## **AGENDA FOR 3<sup>rd</sup> MEETING OF THE NATIONAL COMMITTEE ON DAM SAFETY**

**DATE : 5<sup>th</sup> December, 2023**

**VENUE : 2<sup>nd</sup> Floor, Committee Room, Central Water Commission, New Delhi**

**Figure 2:** Location and number of SMAs to be provided in *Gravity Dams*

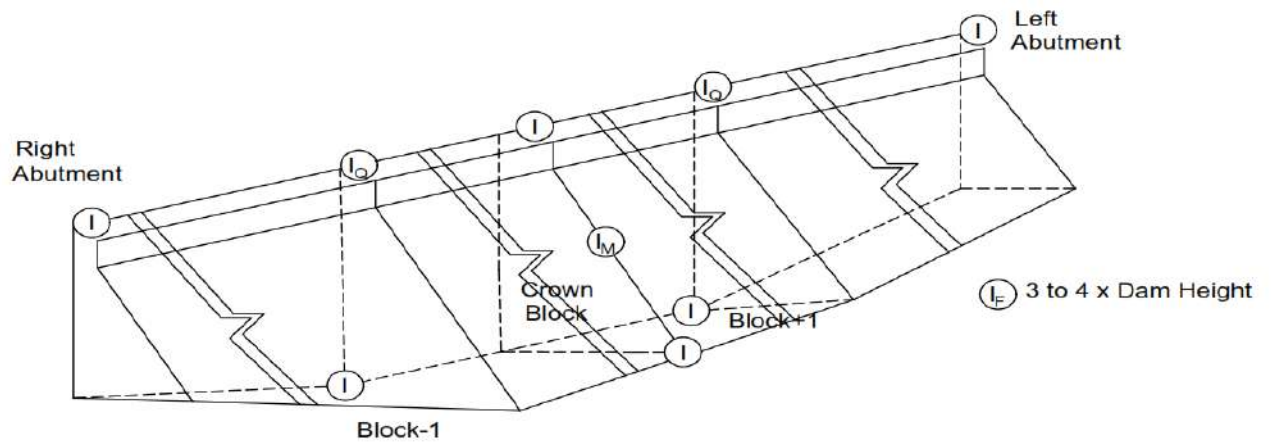
**Figure to be redrawn; some text is unclear**

**Figure 3:** Location and number of SMAs to be provided in *Embankment Dams*

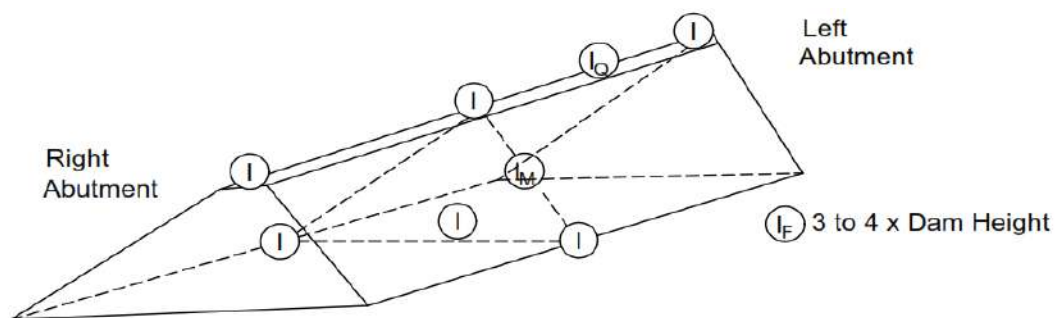
**Figure to be redrawn; some text is unclear**

**Figure to be redrawn; some text is unclear**
